Rocky Mountain Arsenal  
(Operable Unit 27), CO

FINAL  
ASSESSMENT/DECISION DOCUMENT  
UNDERGROUND STORAGE TANK  
MONITORING AND REMOVAL  
Version 1.0

**COMMENTS ON THE  
DRAFT ASSESSMENT/DECISION DOCUMENT  
UNDERGROUND STORAGE TANK  
MONITORING AND REMOVAL**

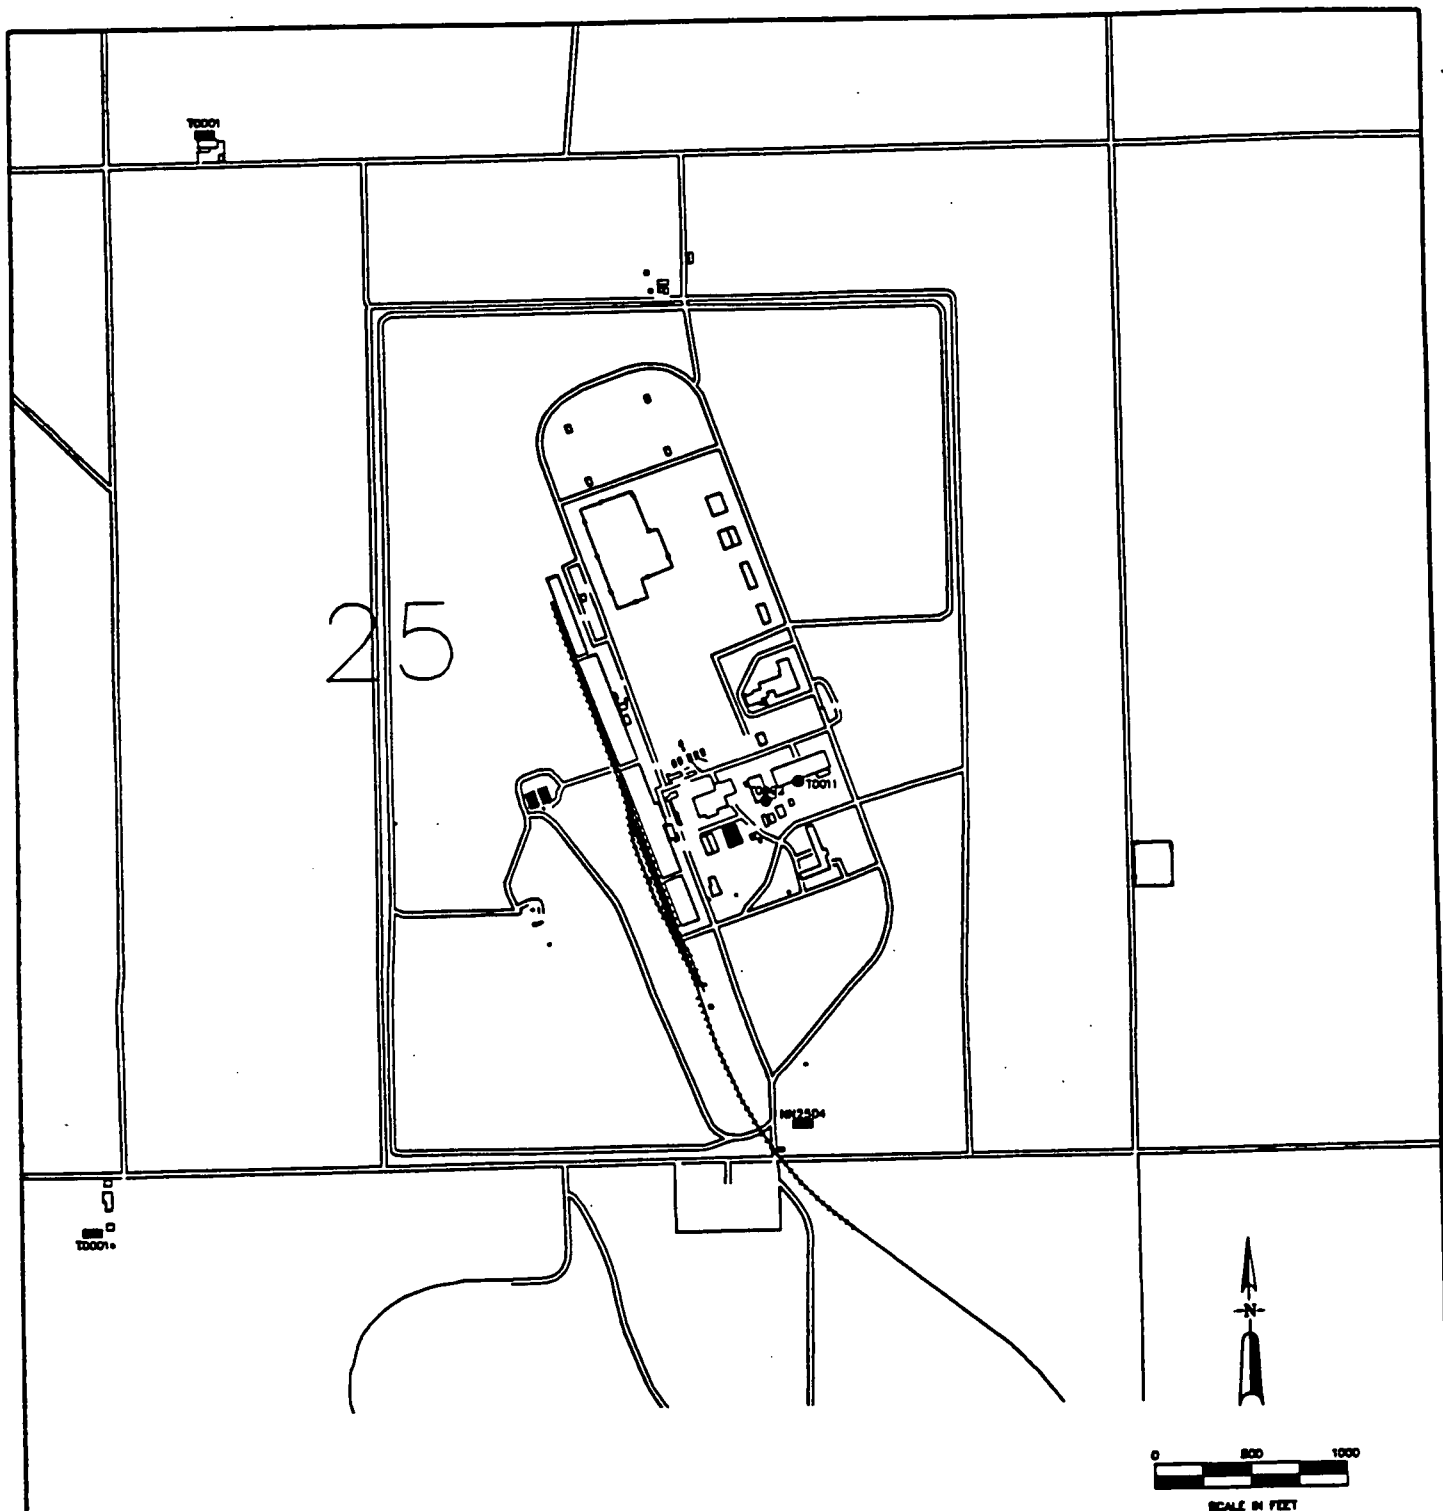
**Comment:** Figure 2-2: The legend shows a tank T0001 as both a hazardous substance waste underground storage tank and a nonregulated underground storage tank, but the figure shows only tank T0001 as a hazardous substance waste underground storage tank. Please clarify.

**Response:** The legend for the tank classification has been modified to reflect tanks as shown on the figure.

### Figure 2-1

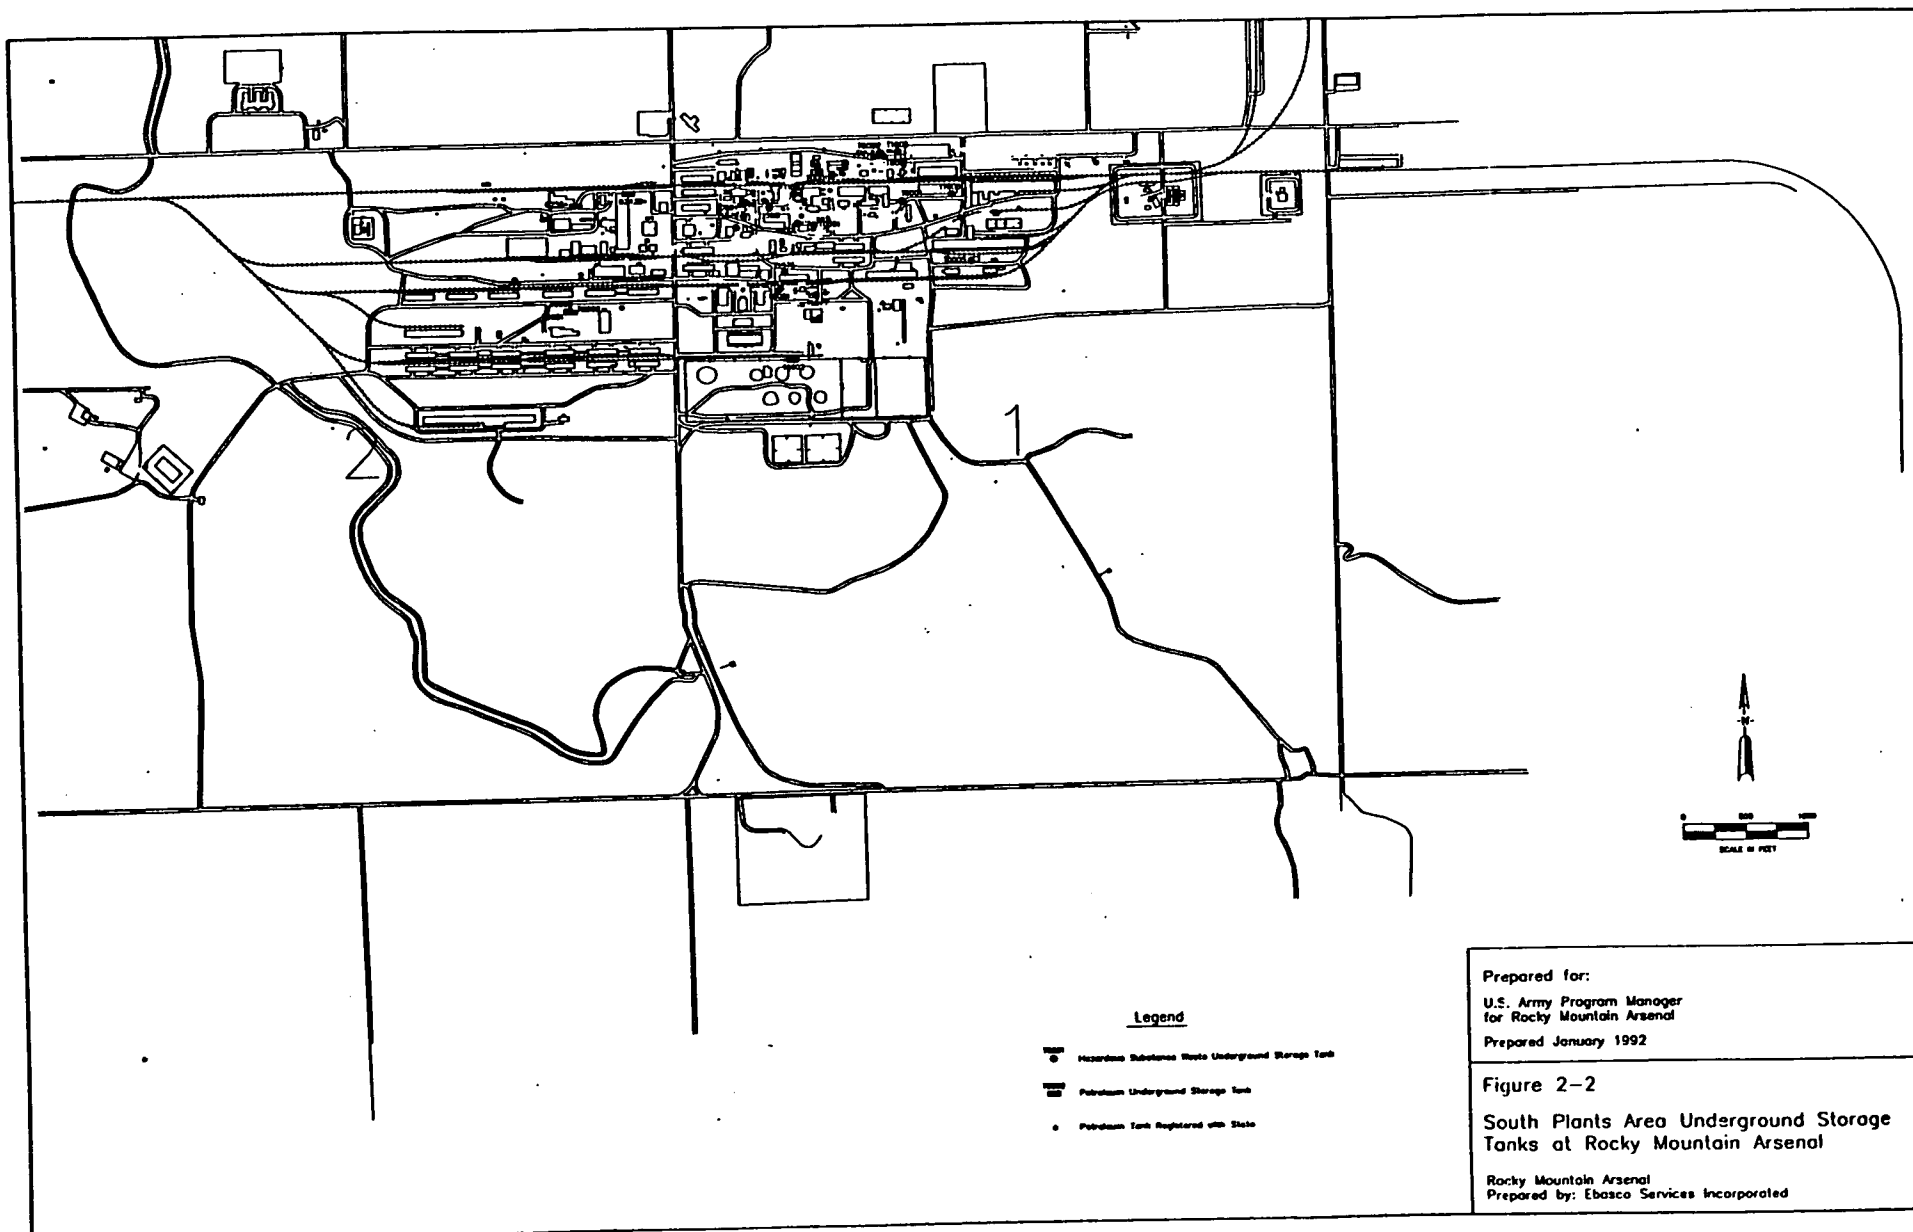
**Comment:** Figure 2-1: The legend shows a tank T0001 as both a hazardous substance waste underground storage tank and a nonregulated underground storage tank, but the figure indicates only a tank T0011 (different number) as a hazardous substance waste underground storage tank. There was some confusion over this figure in the meeting on May 20, 1993, but the figure was not modified. It was EPA's understanding from the meeting that there are two hazardous waste storage tanks in the North Plants and they should be removed as part of this IRA. Please clarify.

**Comment:** 2) Please clarify all potential contents of USTs in the North Plant area. Figure 2-1 indicates that some of the tanks to be removed from this area contain or had contained hazardous substances/wastes. In the UST/PCB subcommittee meeting on May 20, 1993, the Army stated that there are no tanks containing hazardous substances/wastes schedule to be removed from the North Plants area.

**Response:** The legend for the tank classification has been modified to reflect tanks as shown on the figure.

There are two (2) hazardous substance/waste tanks in North Plants. These tanks will be removed by Tennessee Valley Authority (TVA).

**Response:** There are two (2) USTs in North Plants which contain hazardous substances/wastes. These USTs will be removed by Tennessee Valley Authority (TVA).

Figure 2-3  
 Rail Yard Area Underground Storage  
 Tanks at Rocky Mountain Arsenal

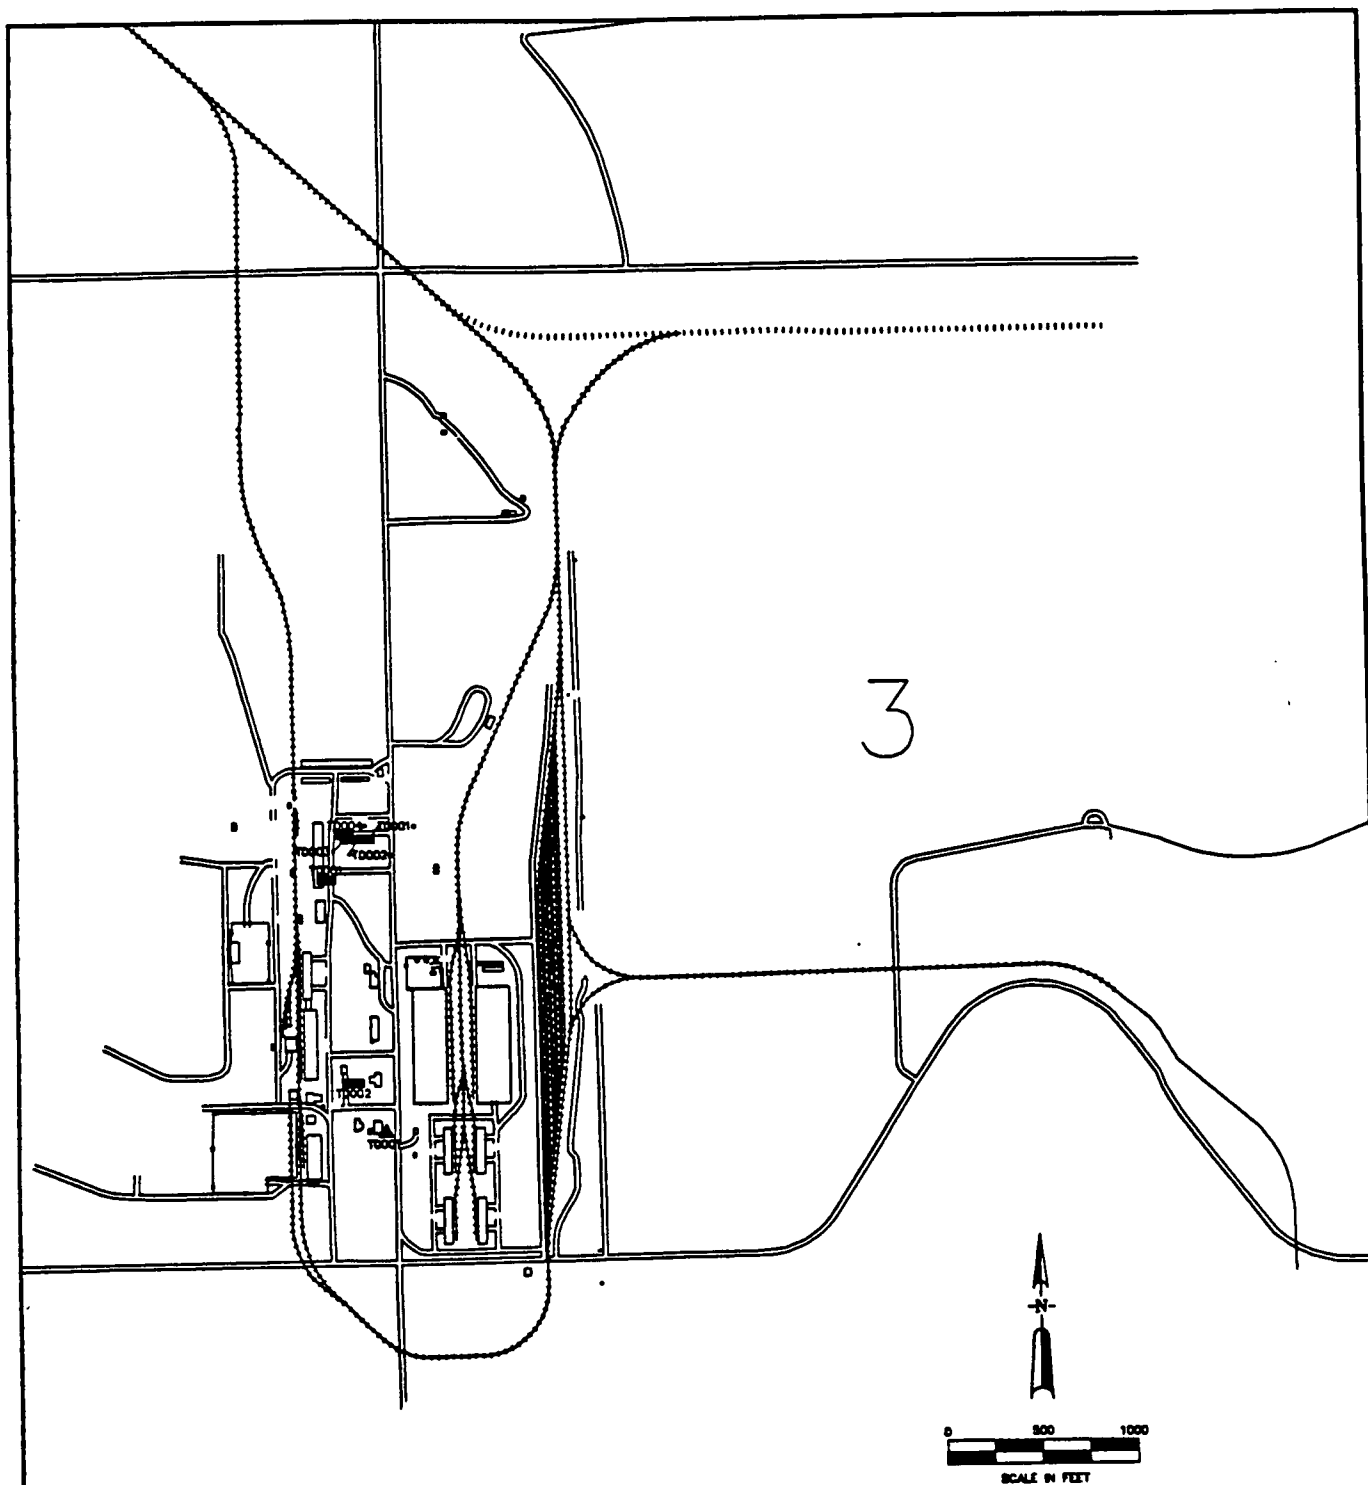
**Comment:** Figure 2-3: The legend shows a tank T0001 as both a hazardous substance waste underground storage tank and a nonregulated underground storage tank, and the figure shows two different types of tank with the same number plus a tank T0001\* as a petroleum underground storage tank. Please clarify.

**Response:** The legend for tank classification has been modified to reflect tanks as shown on the figure. The asterisk (\*) next to a tank is to identify petroleum USTs registered with the State.
